**STATE OF HAWAII
DEPARTMENT OF TRANSPORTATION
HIGHWAYS DIVISION**

**ADDENDUM NO. 1
for
QUEEN KA'AHUMANU HIGHWAY
INTERSECTION IMPROVEMENTS
AT KAWAIHAE ROAD**

FEDERAL-AID PROJECT NO. HSIP-019-1(41)

The following amendments shall be made to the Bid Documents:

STATE OF HAWAII DEPARTMENT OF TRANSPORTATION HIGHWAYS DIVISION	
<u>NESTED LONG SPAN STRONG POST</u> <u>W-BEAM GUARDRAIL OVER CULVERT</u>	
Scale: NTS	Date: 12/1/17
SHEET No. 1 OF 1 SHEETS

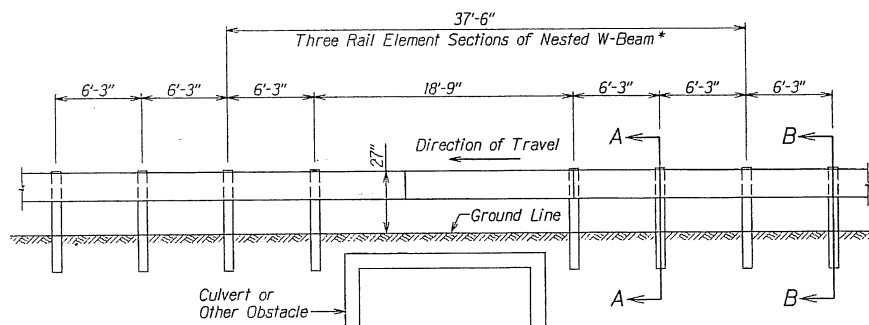
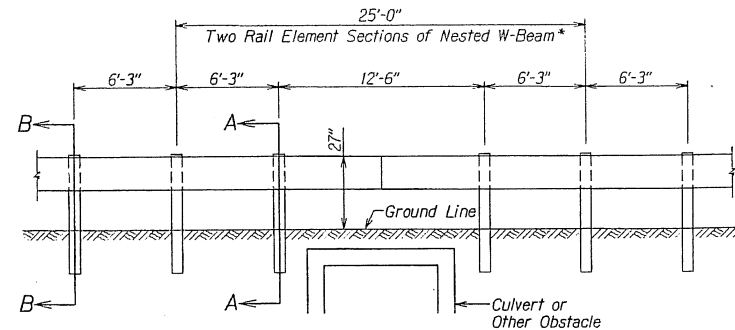
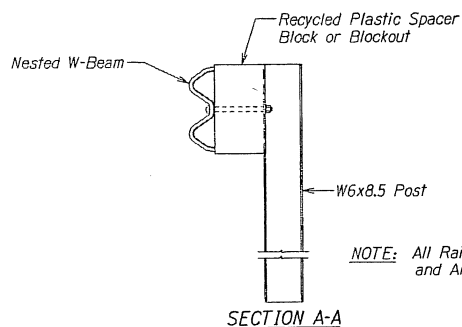
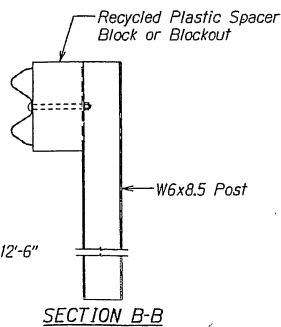
(I) Amend Subsection 606.03(A) – Beam Type Guardrail by adding the following after line 81:

If more than one nested long span is required in the same longitudinal guardrail installation, the nested long spans shall be separated by a minimum of twenty-five (25) feet.”

“606.04 Measurement. Guardrail and reset guardrail will be measured per linear foot. End anchorage, terminal section, and transition section will be measured per each. Nested Long Span shall be considered incidental to guardrail installation and shall not be measured separately.”

4'-0" x 6'-6" x 6'-6" HAWAIIAN TELCOM MANHOLE

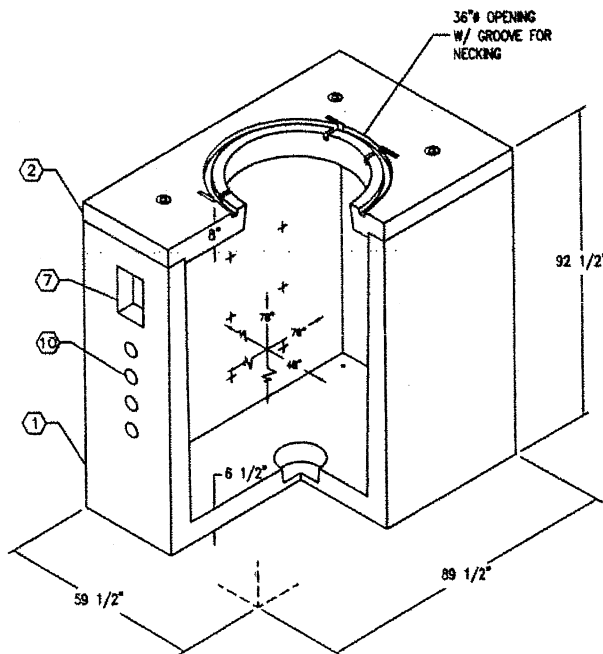
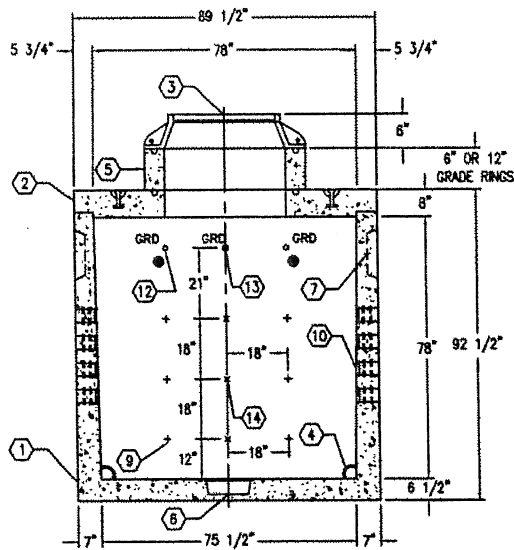
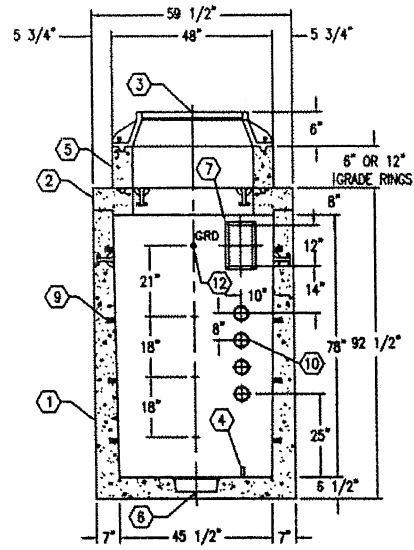
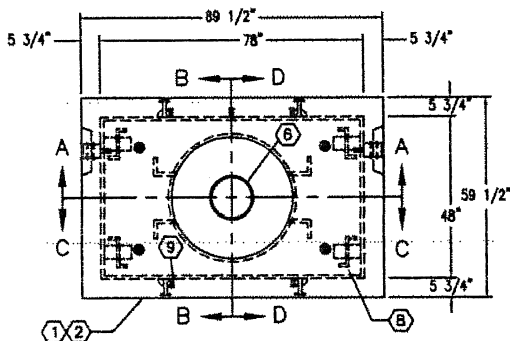
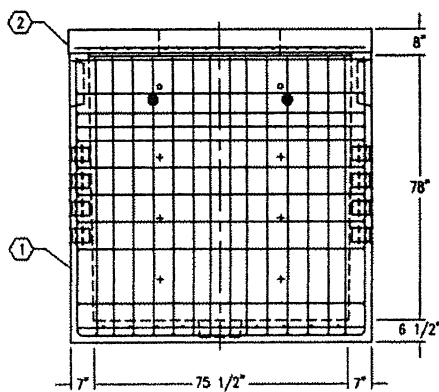
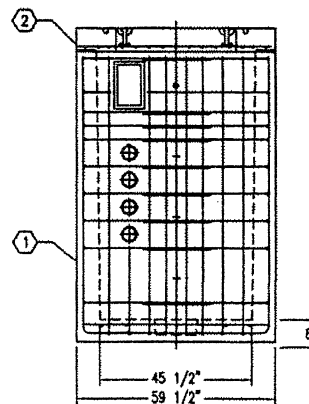
(II) Amend **Section 626.03 Construction** by adding the following after line 171:

Partial details of the 4'-0" x 6'-6" x 6'-6" Hawaiian Telcom manhole are shown on pages 636-2h and 636-3h. Complete details may be found in the Hawaiian Telcom Standard Specifications for Placing Telephone System."
